LIGO-T040096-02-R

Upper-Intermediate Mass for ETM Controls Prototype Quad Pendulum  
Suspension

**Product Design Specification**

### QUESTIONS FOR DESIGN MEETING 013, MONDAY JUNE 28<sup>TH</sup> 2004

**1) Reduce the 'n1' (half separation of the break-offs in y-dir) from 70mm to 50mm:**

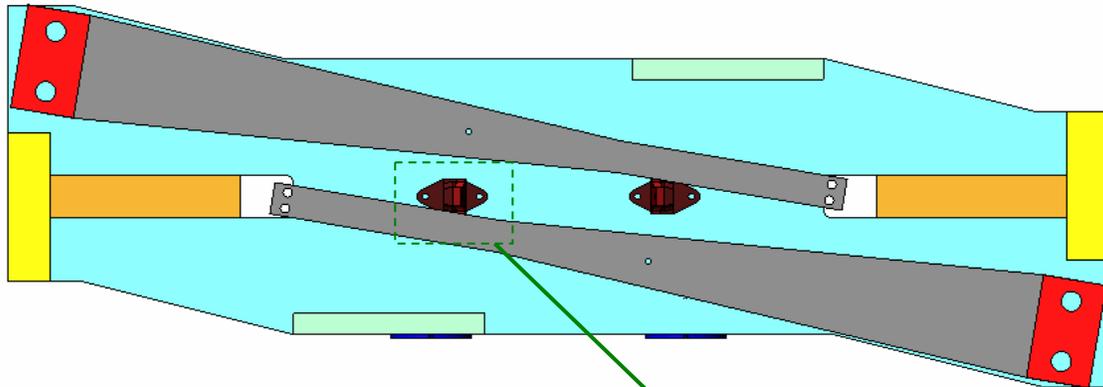
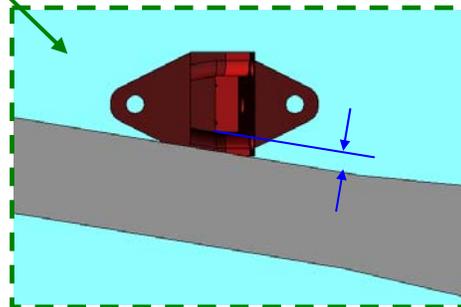
**Problem:** Limited space on U-I Mass bottom plate causes interference between blades and the suspended mass wire clamps.

Calum recommends that we need to have 2-3mm between the blade and the wire clamp to allow for alignment and adjustment.

- i. Can this be done without affecting the suspension performance?

>>>> I need to know whether it would be possible to reduce the n1 value  
>>>> on the Quad to 50mm from 70mm. The problem is that with the current  
>>>> layout the blade will interfere with the clamp. Calum thought that  
>>>> reducing n1 to 50mm shouldn't affect suspension performance greatly  
>>>> considering that the n0 is 200mm.

>>> Changing n1 to 0.05 and also l1 to 0.313 ( from 0.304 ) to keep  
>>> overall length of quad the same does have a slight adverse affect on  
>>> the yaw. The frequencies are Ok but coupling to the highest mode

>>> (at around 3.1 Hz) gets worse - typically the Q doubles. Although  
>>> this isnt directly affecting the settling time, which is dominated  
>>> by the lowest mode, I am musing about whether there could be any  
>>> problems (for example applying Ken's latest ideas about damping as  
>>> combination of active for the low freqs and ECD for the higher  
>>> ones). I want to muse a bit longer. Will get back to you soon.

>> I wanted to ask if making n1 0.06 is enough of a change to fit in  
>> wire clamps - it gives a less significant change to the yaw  
>> behaviour. I am still musing on whether the 0.05 is acceptable but  
>> thought i would ask anyway.

> As we are looking at altering the blade to having a narrower tip it is  
> not necessary to move the break-off as far from the 0.07m as I  
> proposed. I have checked the model - moving the wire clamp to 0.06  
> from the centre of mass - and this seems to be okay.

That's good! Let's settle for n1 = 0.06. I'll check what l1 has to be to  
keep overall length same.

It is best that a combination of solutions proposed in 1 and 3 are adopted for the design.

- Use a narrow blade design with #8-32 holes along the length of the blade.
- Reduce n1 to 60mm.

2) Angle blades further. Diagram shows increase from 9.5degrees to 12degrees:

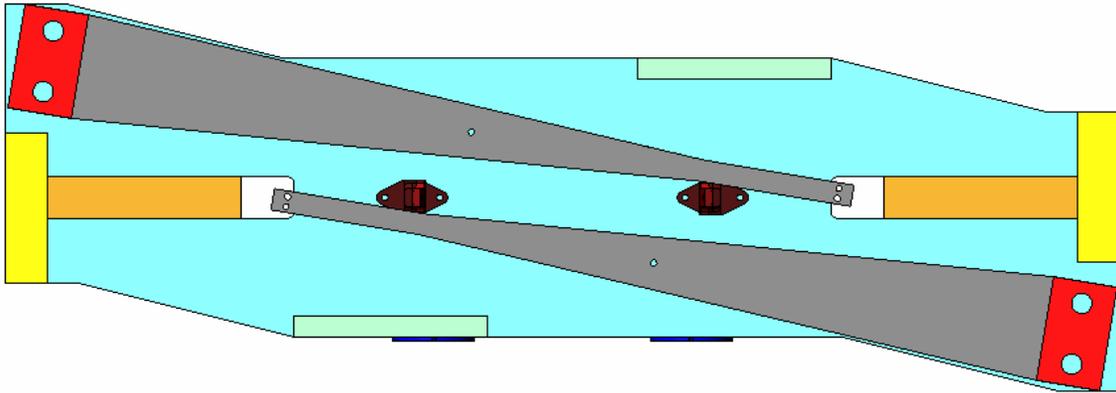
- i. Off-axis Moments (Lxy, Lyx, highlighted in **RED**) increase such that they are higher than Moments in the Y plane (Lyy).
- ii. Norna – I expect that this is not good?!

### 3) Reduce blade width at tip to 10mm:

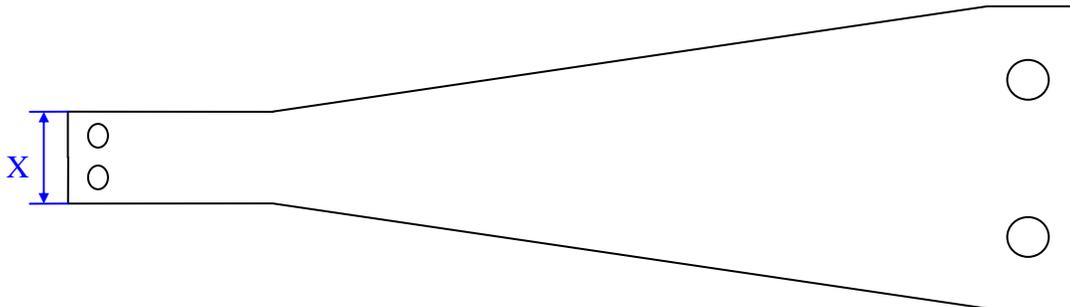
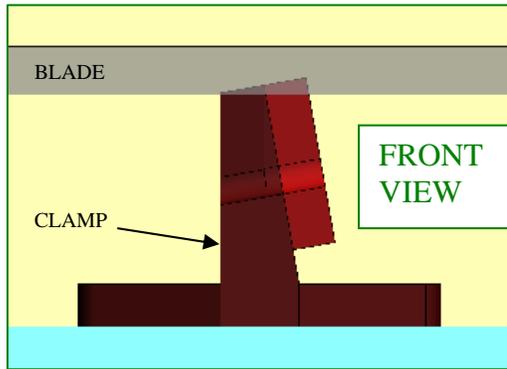
```
>>>Would it be okay to move to a 10mm width at the thin end instead of
>>>15mm?
```

```
>>To answer your question about the blades. It sounds like the design
>>you are proposing has a trapezoidal shape. Is this correct? I suppose
>>the issue then is how much material there is around the holes drilled
>>for the clamp. If the holes are one behind the other then 10 mm width
>>is probably OK. Of course the spring constant of the blade will be
>>slightly
```

1. The bolts are strong enough for the loads involved
2. The bolt heads do not interfere. (I would think that the holes must be drilled fairly close to the edge for this not to be a problem, unless you envisage a special clamp design).

- i. Is this going to affect the blade performance? Shouldn't be a problem – Comments from DM013.
- ii. Can we use #4-40 bolts for the blade wire clamp? Probably be okay (original BWC concepts has #2-56 but deemed fiddly to work with) but maybe we could use #8-32 but position the holes along the blade.

**NOTE:** #4-40 Socket Head bolts have a maximum head diameter of 0.183in (4.65mm) therefore two can fit laterally on a 10mm blade tip.

**4) Raise Blades to Avoid Interference:**

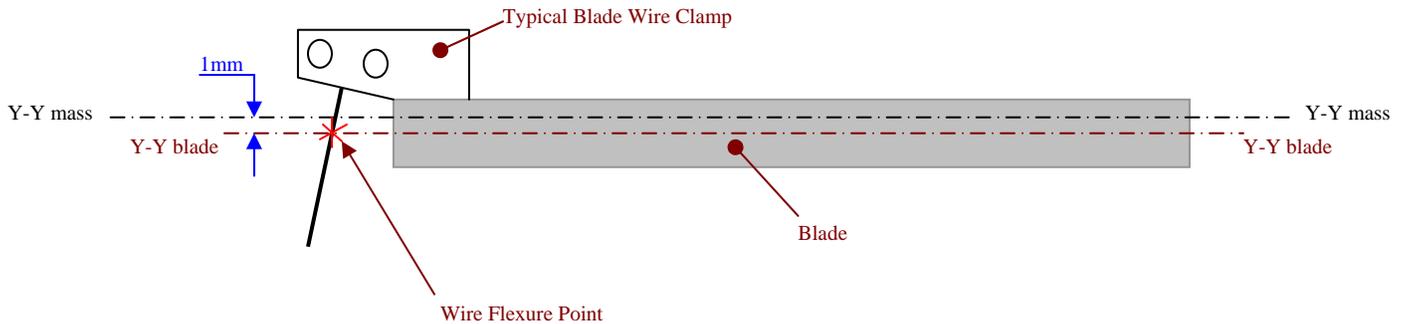
The blade collides with the clamp in the Y-Z plane by around 1.5mm. Could we raise the height of the blade to avoid this interference (adjusting for the break-off height via the blade wire clamp)?

- i. As the blade is not guaranteed to be perfectly flat under load, there is still a possibility that the blade will hit the clamp when loaded.
- ii. Moving the blade from the default position, and compensating with the clamp, will cause a cross coupling which will in-turn affect the suspension performance.
